FOREST LAKES FILING NO. 7

COUNTY OF EL PASO, STATE OF COLORADO

CONSTRUCTION PLANS

MAY 2021

NO.	REVISION	DATE																						
DESIGNED BY	MAL	SCALE	DATE	05/21/21																				
DRAWN BY	MES	(H) 1" = 50'	SHEET	2 OF 31																				
CHECKED BY	(V) 1" = N/A	JOB NO.	1175.70

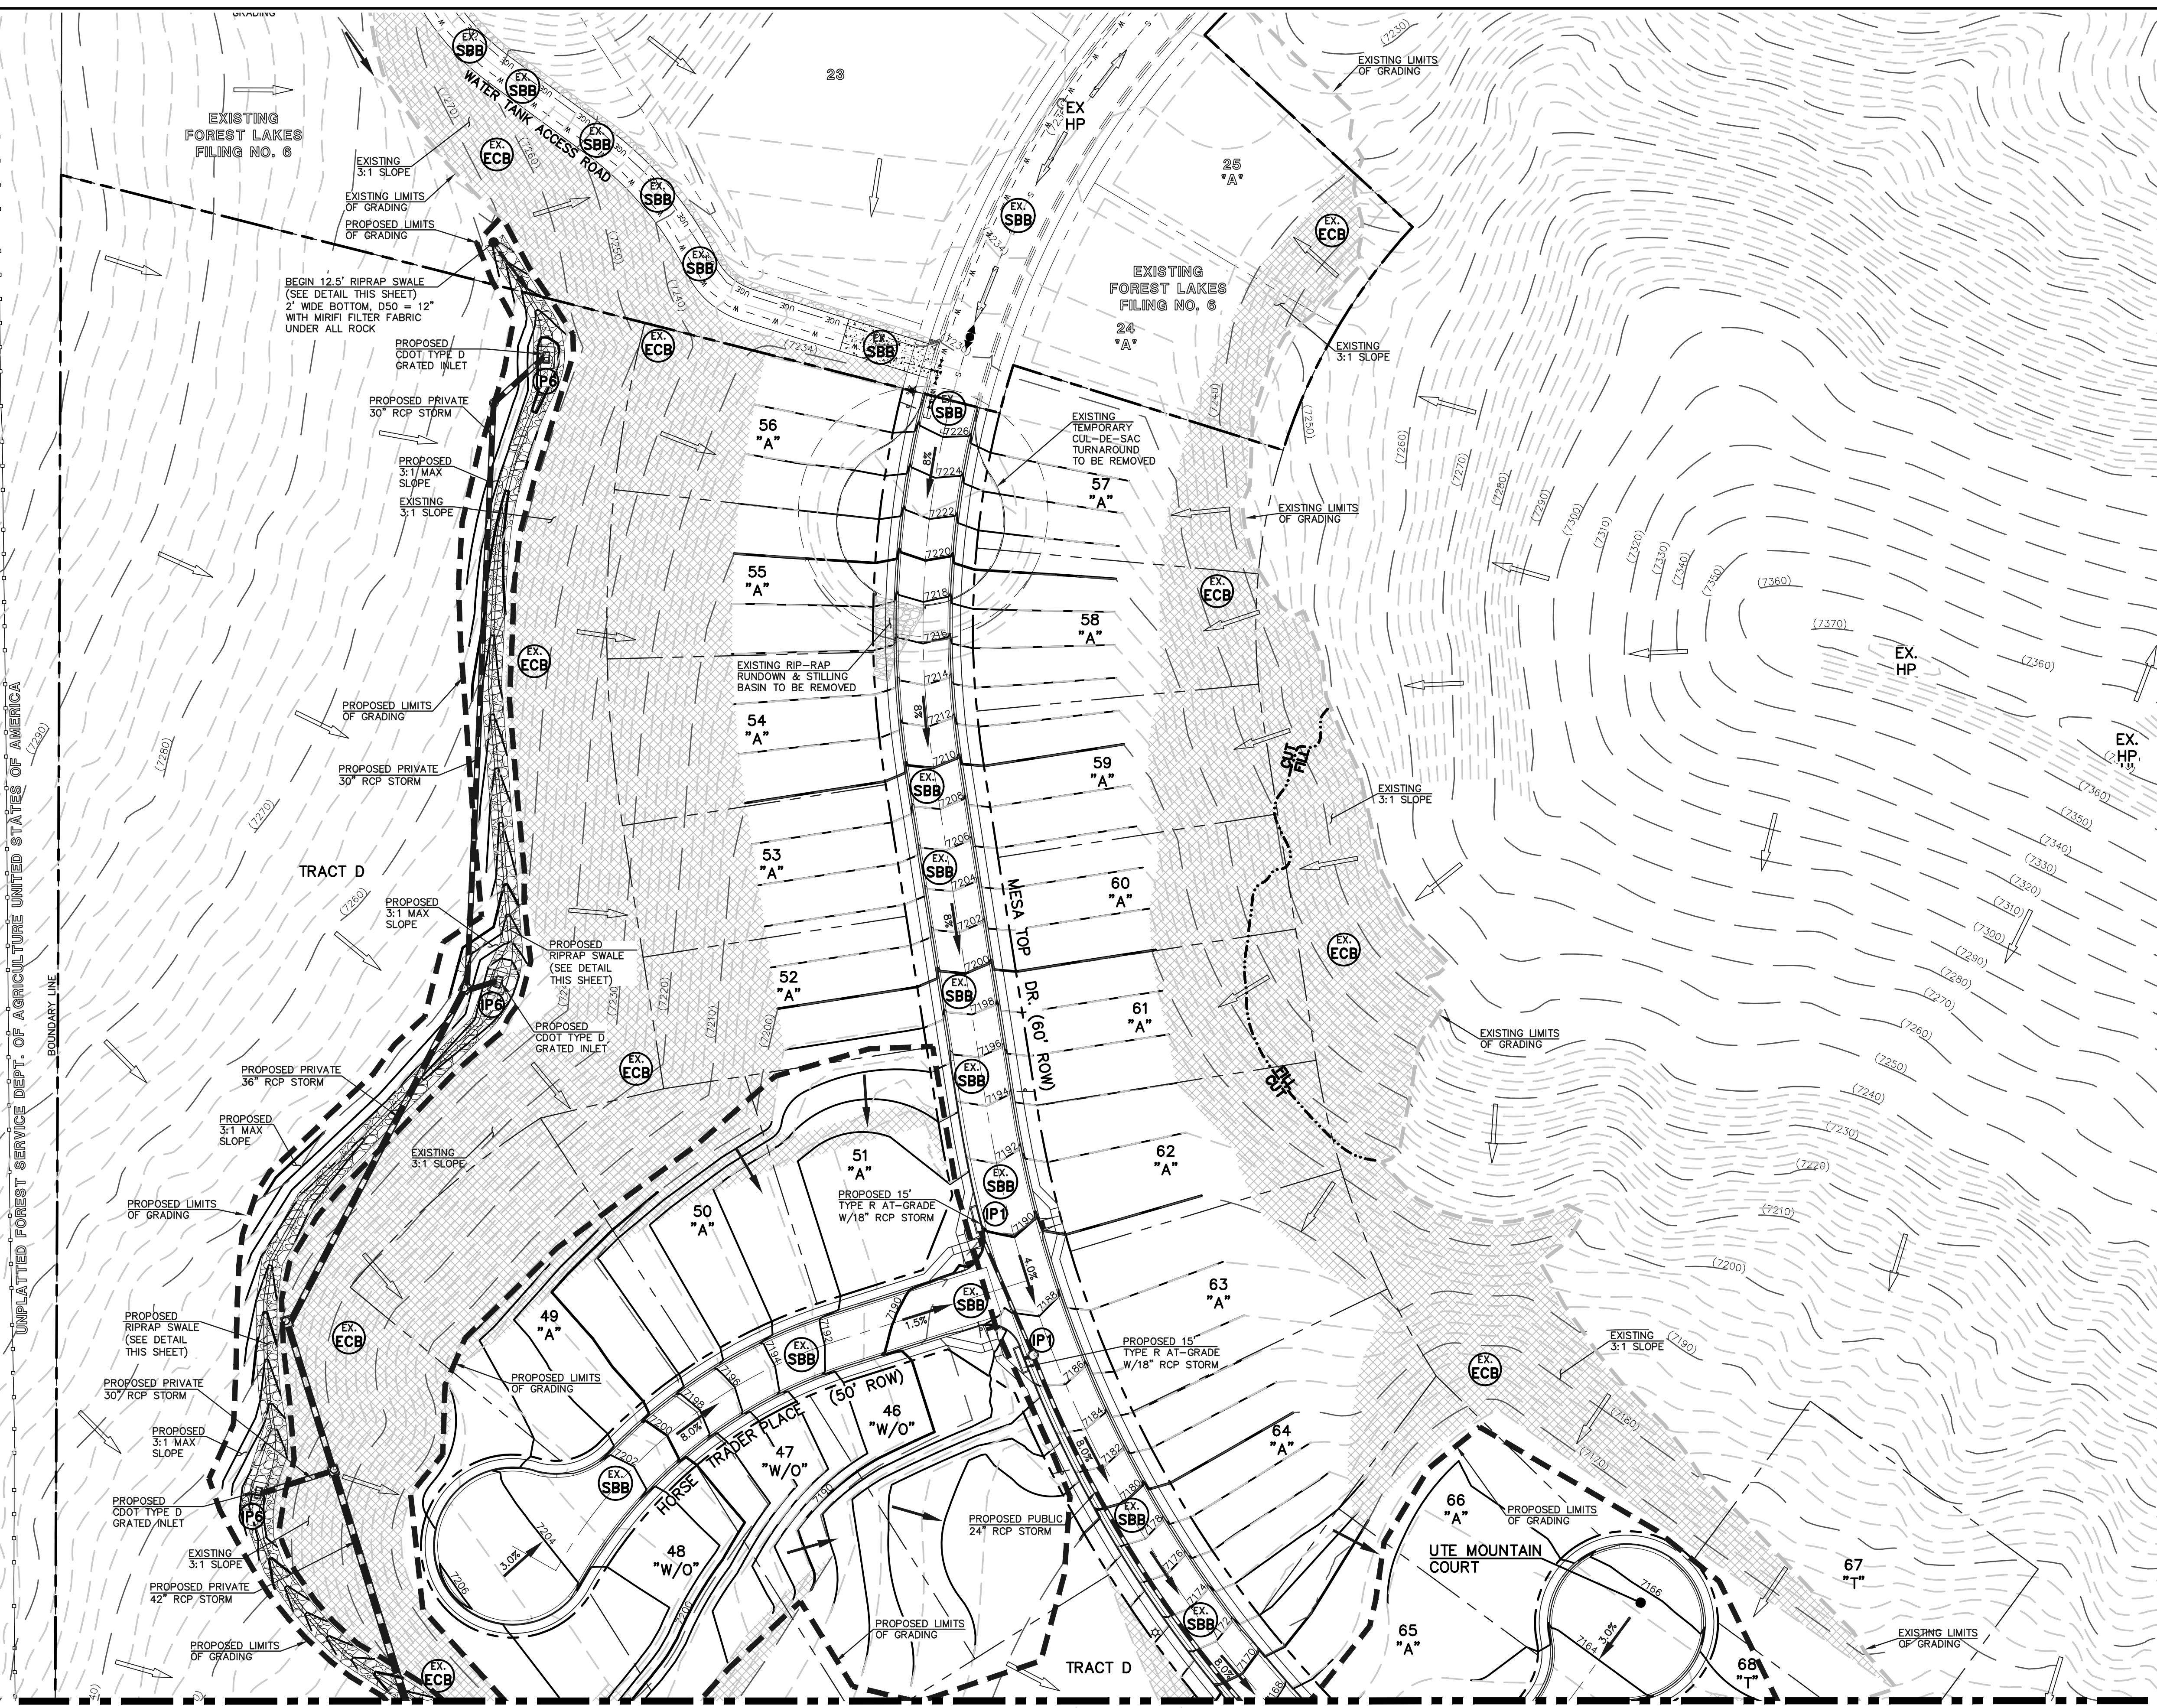
To comply with the SWMP Checklist Item 17f, please add a note stating no batch plants will be utilized onsite.

DESIGNED BY	MAL	SCALE	DATE	05/21/21
DRAWN BY	MES	(H) 1" = 50'	SHEET	4 OF 31
CHECKED BY	(V) 1" = N/A	JOB NO.	1175.70

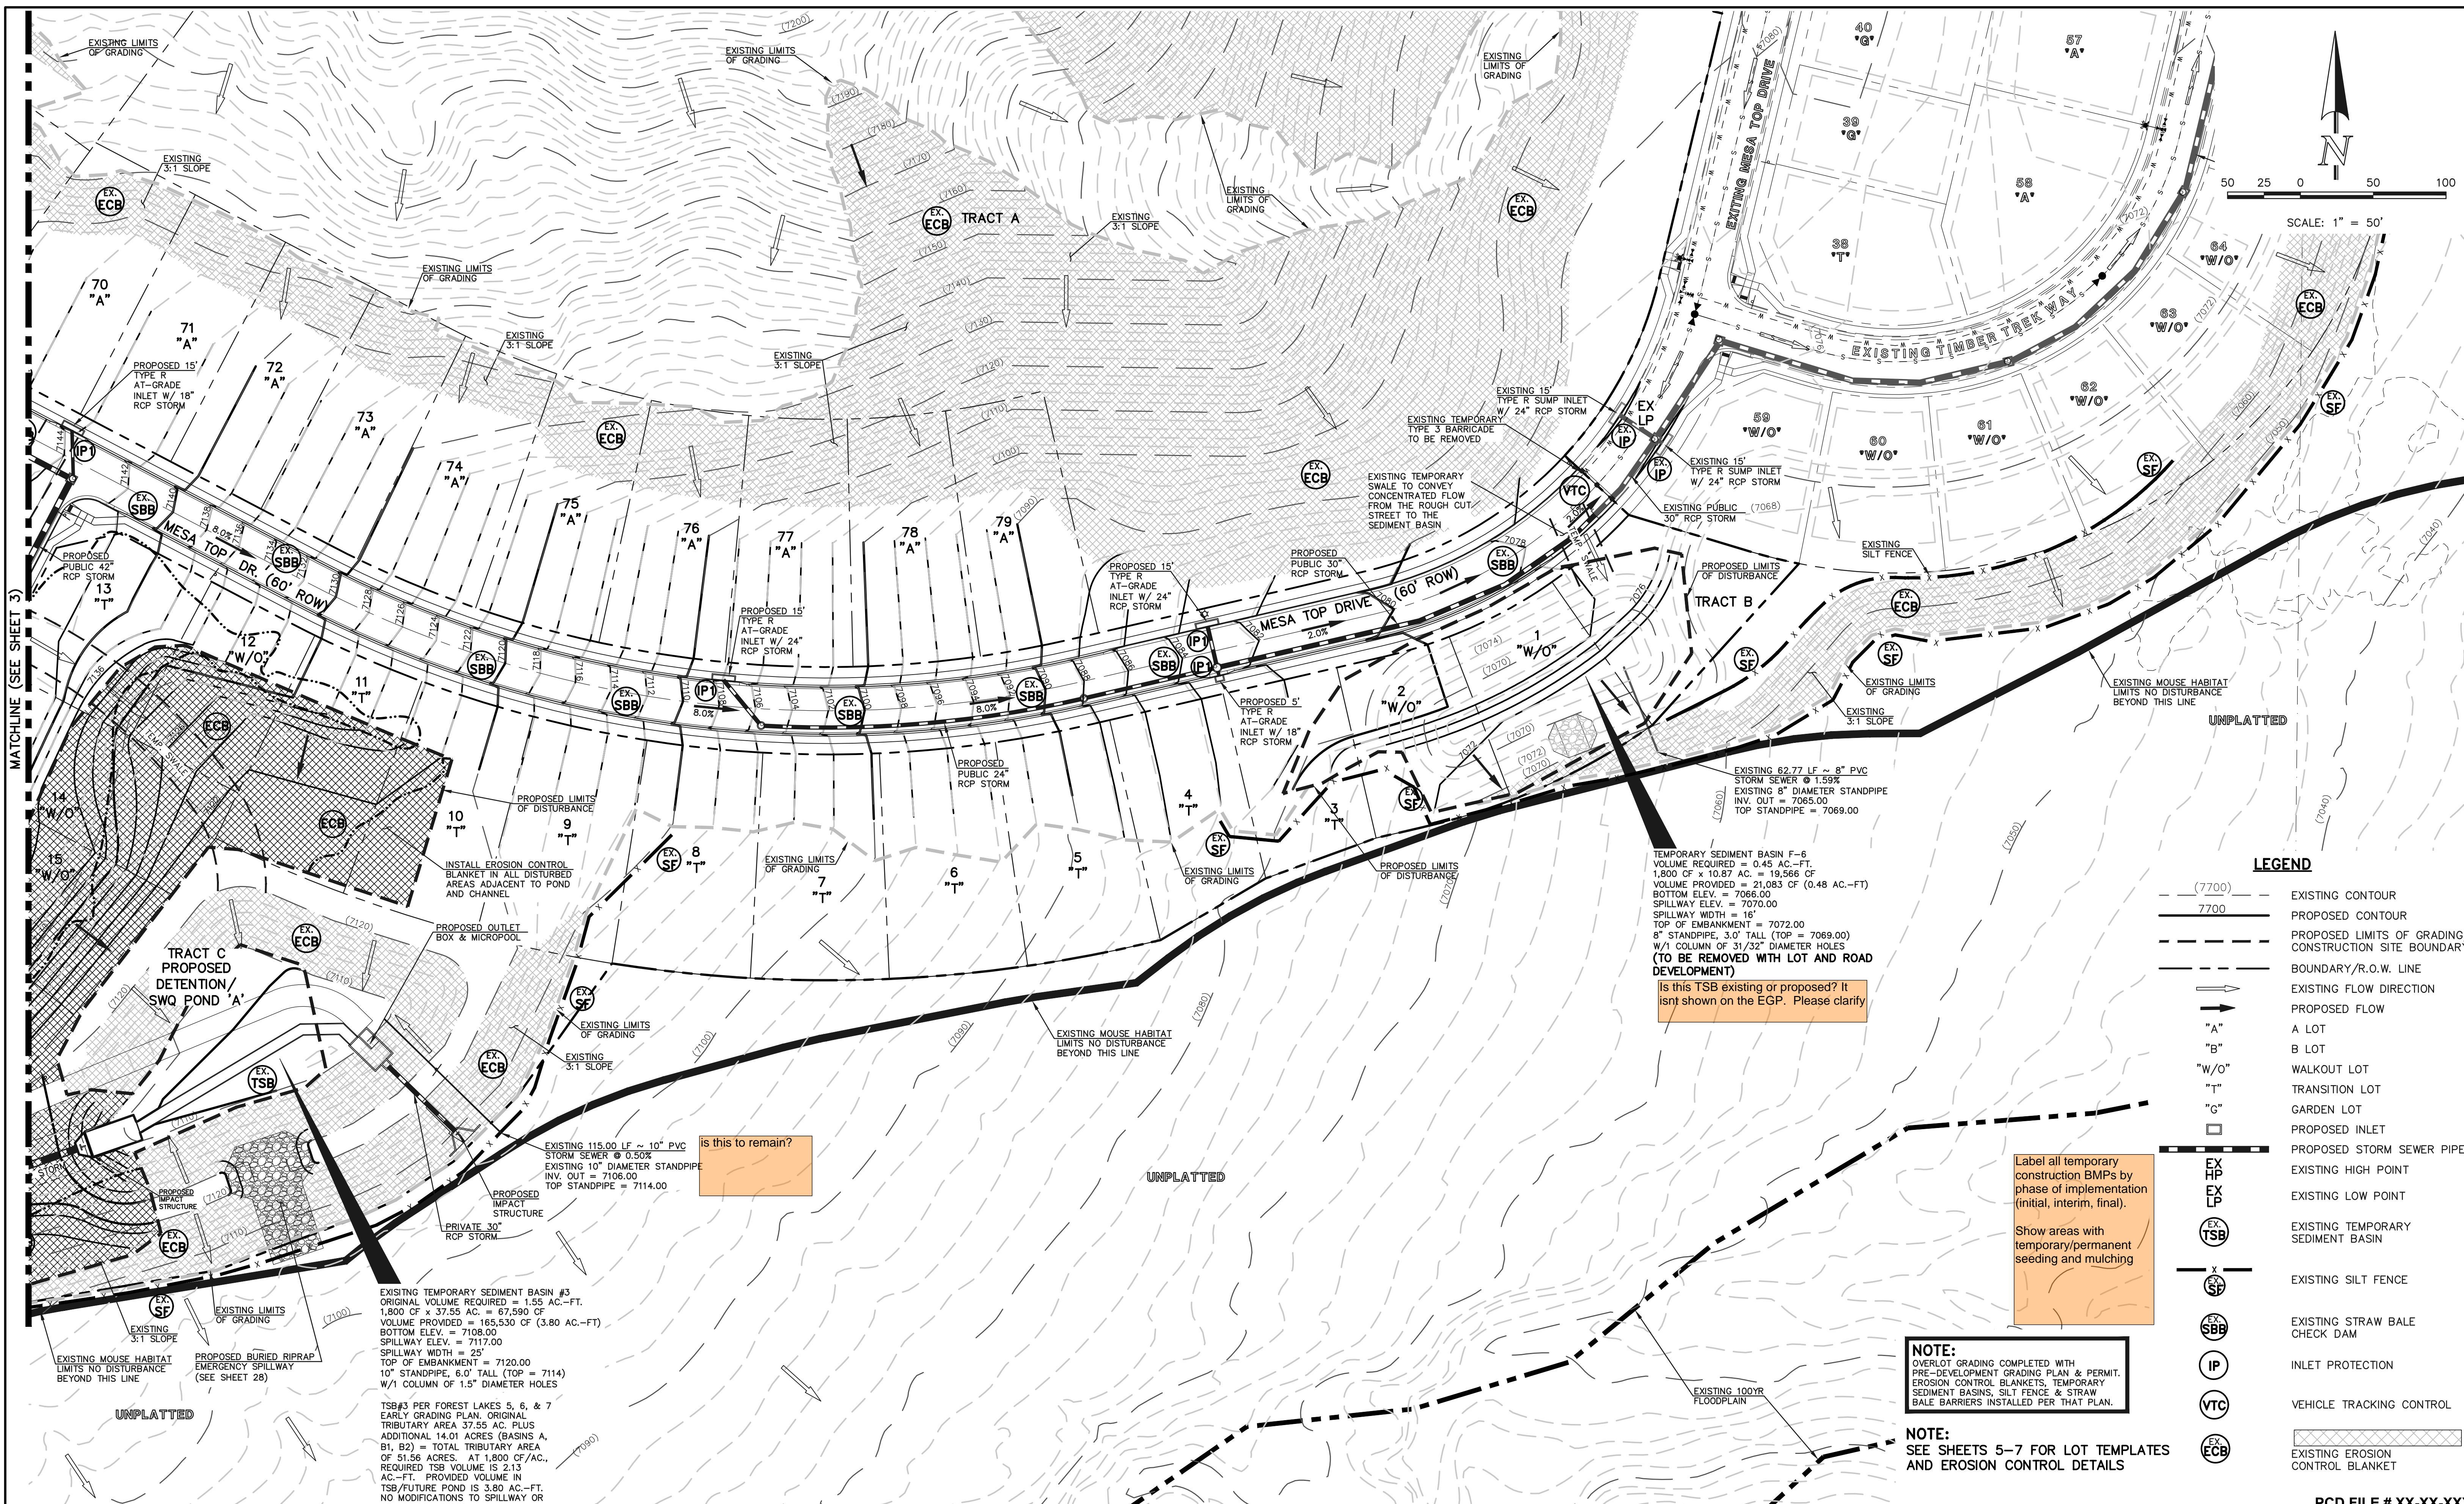
is this TSB existing or proposed? It isn't shown on the EGP. Please clarify

Show areas with temporary/permanent seeding and mulching
